ITEM: 6.14	REPORT SUMMARY MINOR VARIANCE APPLICATION FILE NUMBER A093/24
-------------------	--

MINOR VARIANCE APPLICATION FILE NUMBER A093/24

CITY WARD #:	2
APPLICANT:	York Catholic District School Board
AGENT:	Chris Maves, Nick Swerdfeger & David Bovill
PROPERTY:	7501 Martin Grove Road, Woodbridge
ZONING DESIGNATION:	See below.
VAUGHAN OFFICIAL PLAN (2010) DESIGNATION:	City of Vaughan Official Plan ('VOP 2010'): "Parkway Belt West Lands"
RELATED DEVELOPMENT APPLICATIONS:	DA. 20.018.
PROPOSAL:	Relief from the Zoning By-law is being requested to permit the addition of portable classrooms onsite and to facilitate related Site Plan Application DA. 20.018.

PROJECT:
NEW PORTABLES AT HOLY CROSS CATHOLIC ACADEMY
7501 MARTIN GROVE ROAD
WOODBIDGE, ON
YORK CATHOLIC DISTRICT SCHOOL BOARD

3 A101 PART SITE PLAN 1:200

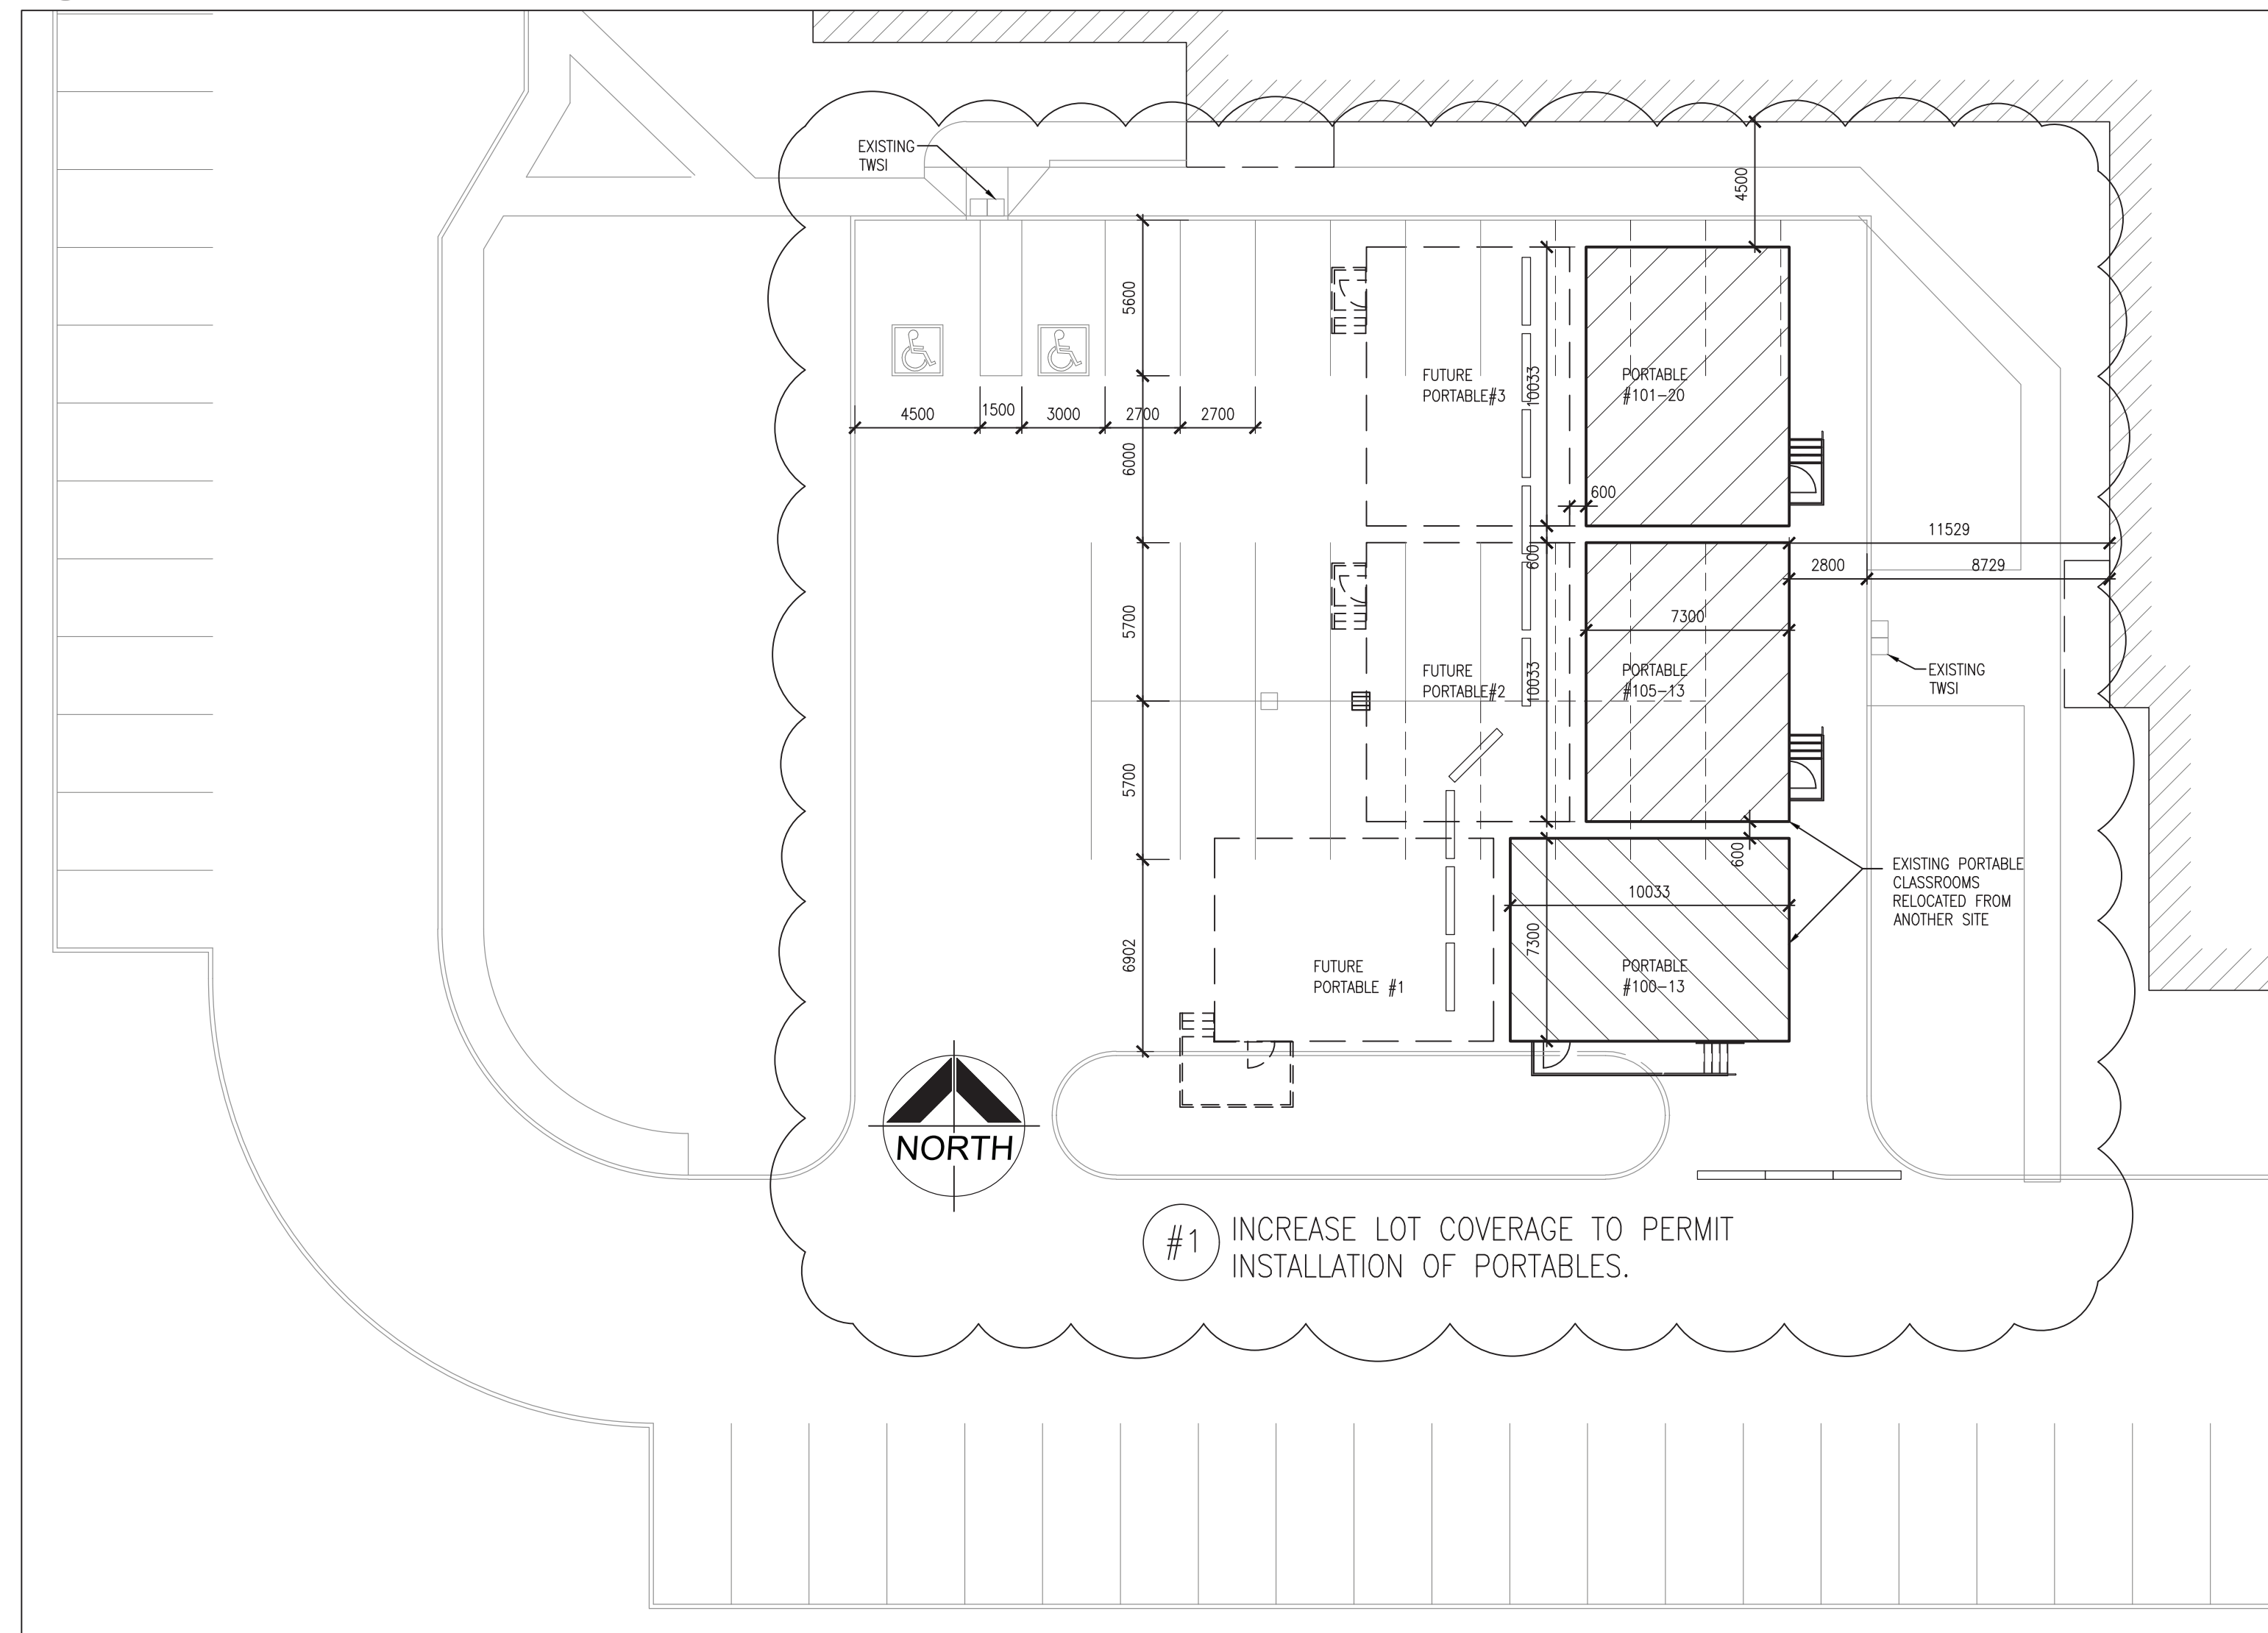
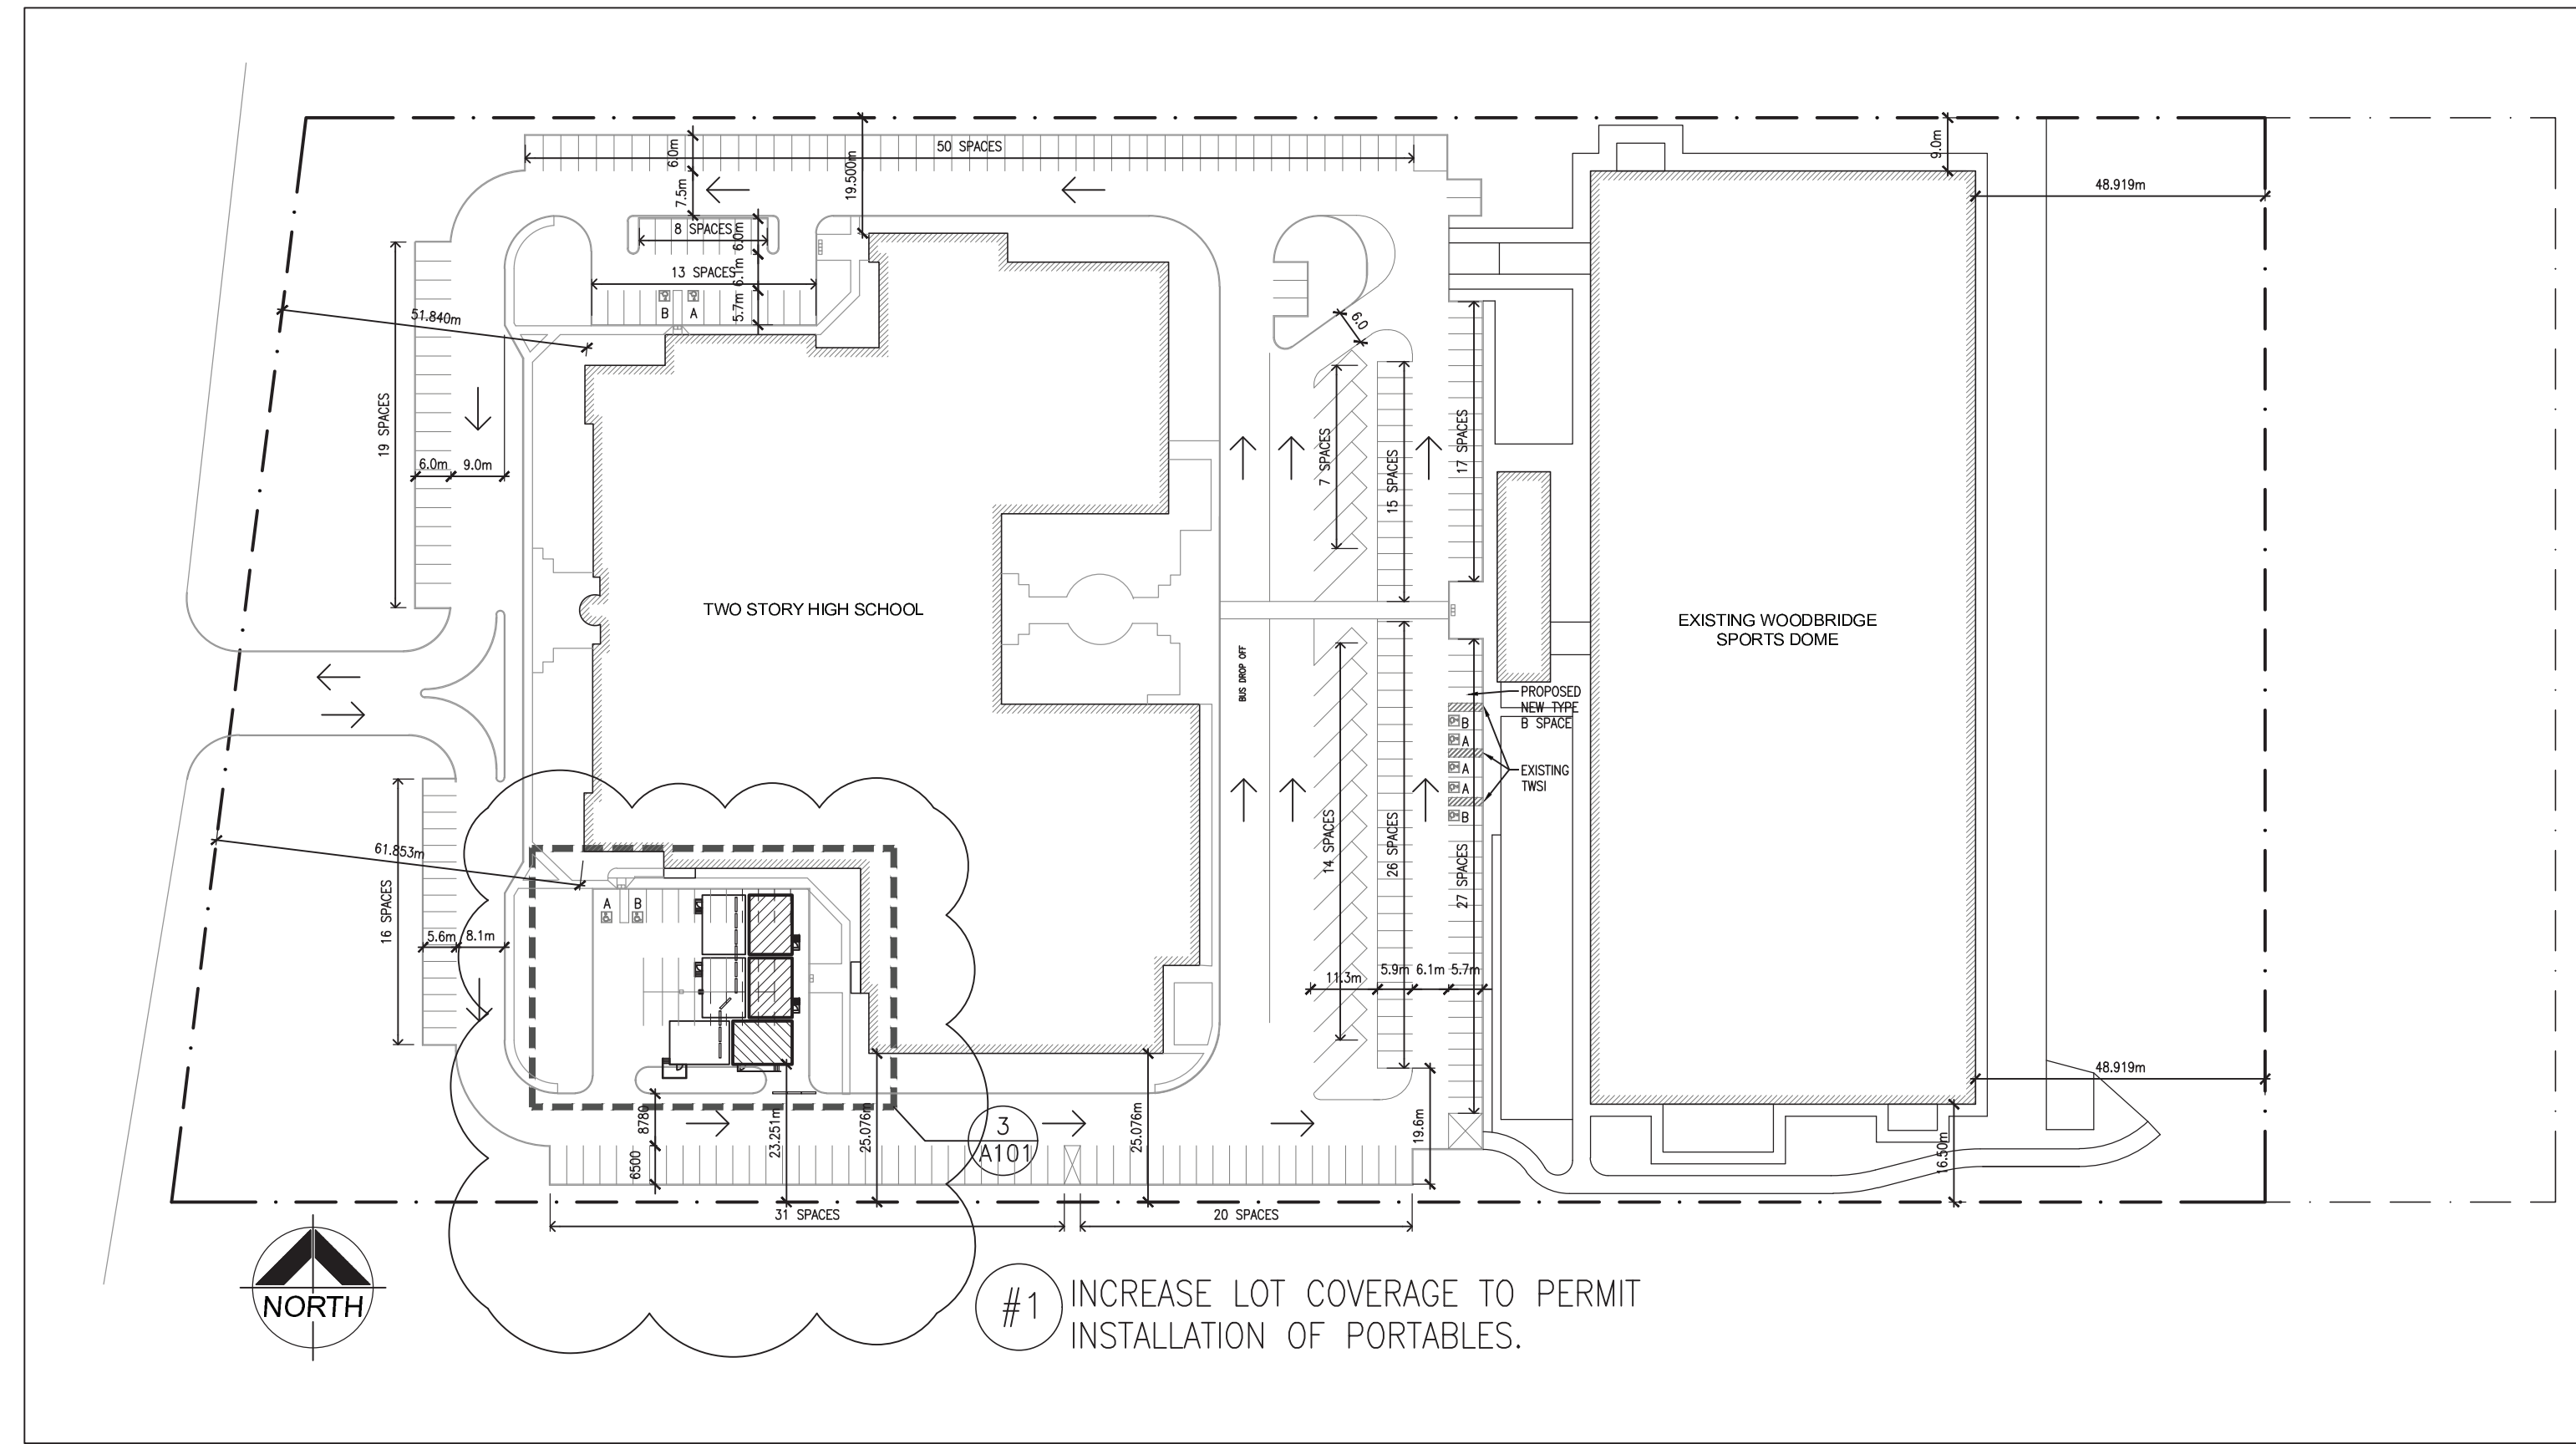
*Plan no reviewed by zoning updated lot coverage to be consistent with zoning comments.
